**RE: LFPCN 41395 - TVS STD DO-214AC(SMA) and DO-214AA(SMB) packages
additional Assembly/Test location approval**

Product/Process Change Notice (PCN)

PCN#: LFPCN #41395 **Date:** Nov 3rd, 2021

TVS STD DO-214AC(SMA) package and
DO-214AA(SMB) package

Current site

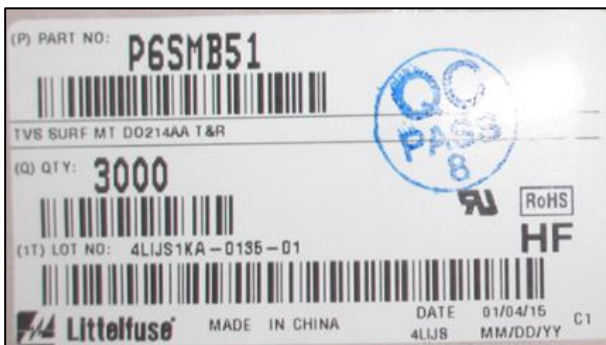
5.2 Reel

New additional site

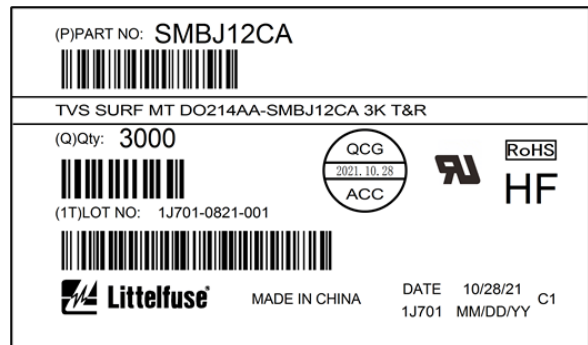
Packing	Current site	New additional site
Tape	Hot seal carrier tape	Hot seal carrier tape
Reel	Dark Blue Plastic Reel, 13 inches	Blue Plastic Reel, 13 inches
Pizza Box	345mm*336.5mm*21mm	
Label	Size: 70mmx38mm	Size: 70mmx40mm
Outside Box	350mm*350mm*50mm (1 to 2 Pizza Box) 350mm*350mm*100mm (3 to 4 Pizza Box) 350mm*350mm*195mm (5 to 8 Pizza Box) 350mm*350mm*345mm (9 to 14 Pizza Box)
